# Maitland Bay Drive and Picnic Parade intersection upgrade

Community Consultation Report

Roads and Maritime Services | July 2019

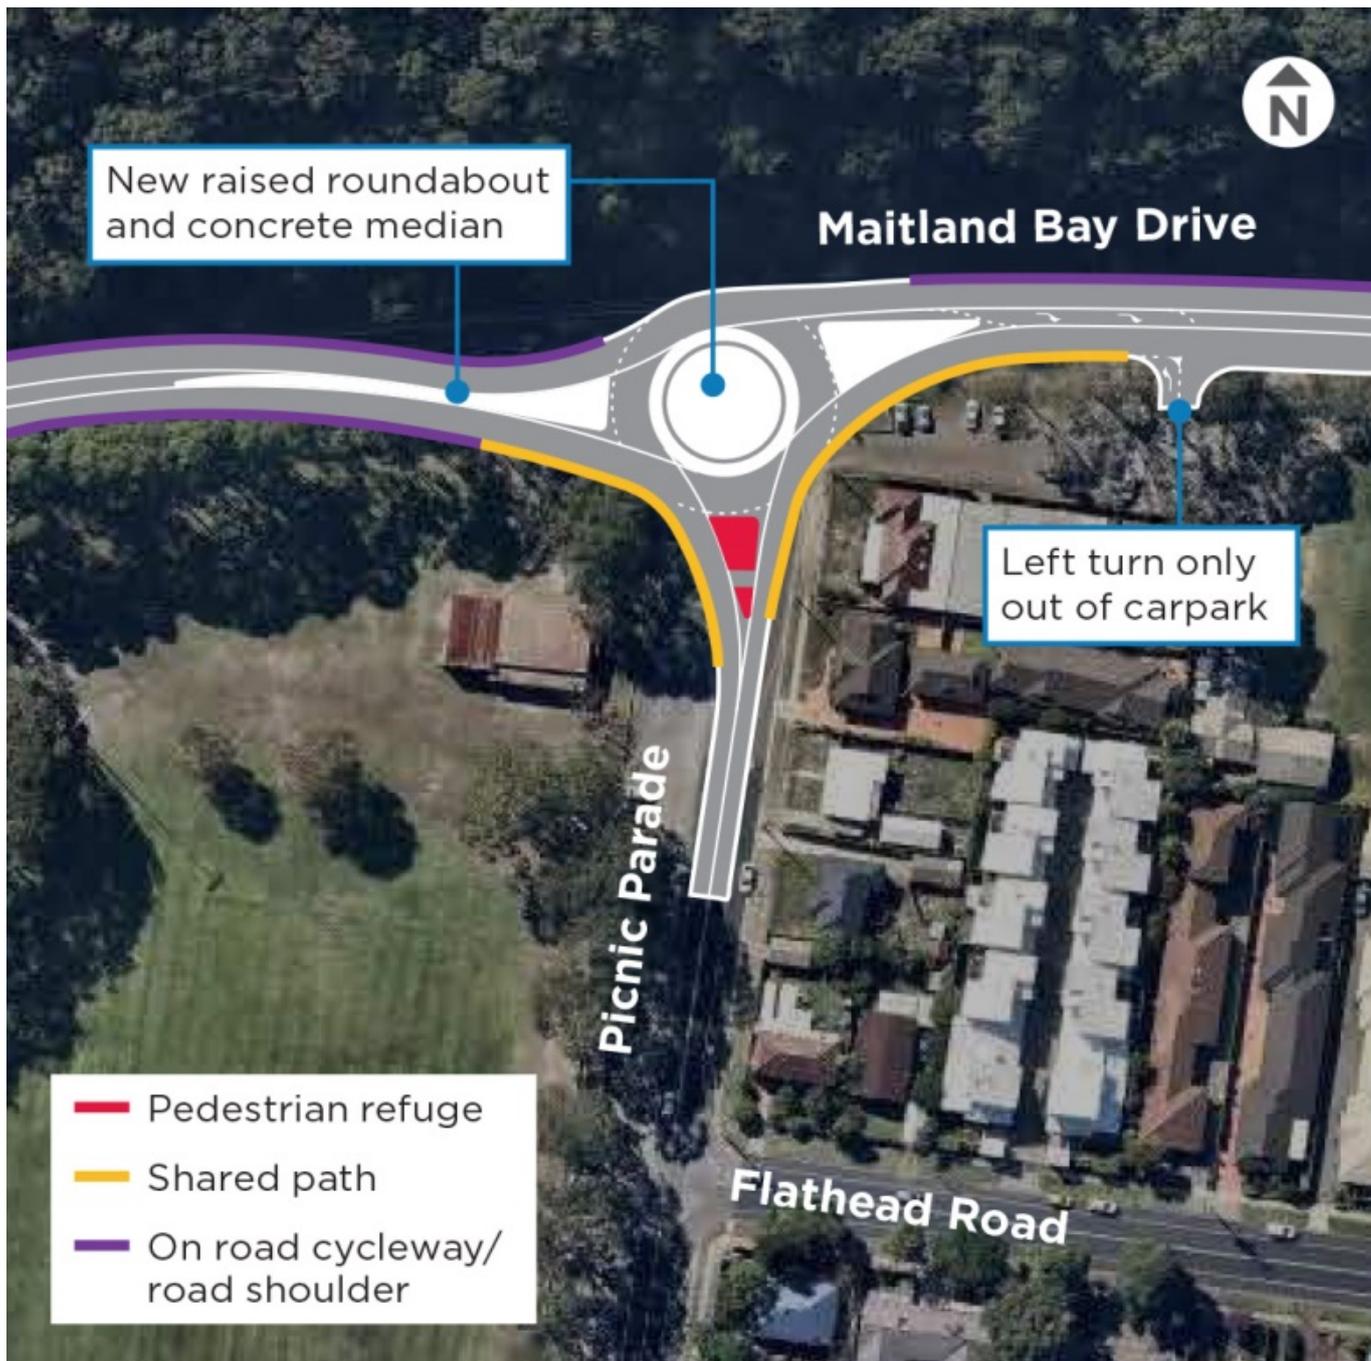
Issue	Sub issue	Issue raised	Roads and Maritime response
<b>Design</b>	Roundabout	<p>Comments on the proposed roundabout design include:</p> <ul style="list-style-type: none"> <li>• It will result in worse traffic build up</li> <li>• The roundabout will be over engineered with large expanses of concrete</li> <li>• Two lanes should be provided in each direction</li> <li>• Traffic will be slowed on Maitland Bay Drive</li> <li>• The roundabout will not solve safety issues</li> </ul>	<p>The concerns raised by the community are acknowledged. Feedback received through this consultation will be considered during development of the concept design which is expected to be finalised later this year.</p> <p>Traffic modelling of the displayed layout for the proposed intersection upgrade indicates it will continue to work for 20 years without reaching capacity.</p> <p>The single lane approach on Picnic Parade is suitable because the roundabout physically reduces approach speed on Maitland Bay Drive. This enables more frequent entry into the roundabout from Picnic Parade as smaller gaps can be accepted.</p>

<b>Traffic</b>	Congestion	There were questions raised about the roundabout actually hindering the traffic flow, rather than improving it, particularly in peak times while several respondents said how bad the traffic was already during peak morning and afternoon times.	<p>Modelling of the displayed layout for the proposed intersection upgrade indicates it will continue to work for 20 years without reaching capacity. The existing layout would make Picnic Parade unusable within the next 15 years.</p> <p>The single approach on Picnic Parade is suitable because the roundabout physically reduces approach speed on Maitland Bay Drive. This enables more frequent entry into the roundabout from Picnic Parade.</p>
